NEW ELECTRIC VALVE "FE 40"

"FE 45" END OF PRODUCTION

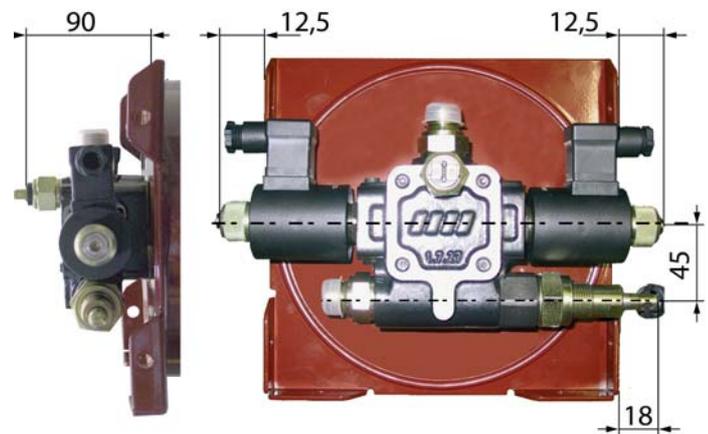
In few weeks the electric tipping valve FE 45 will be replaced by the new one named FE 40 having similar technical features but slightly different overall dimensions.

As shown in the picture, the hole pattern, ports and relief valve arrangements are just the same, while the **coils, pressure switch port and mechanical end-of-stroke are moved into a different position compared to the old model.**

Thus, we would suggest you to check in time any possible interference in respect of standard applications since just a few units of the old valve FE 45 will be available again.
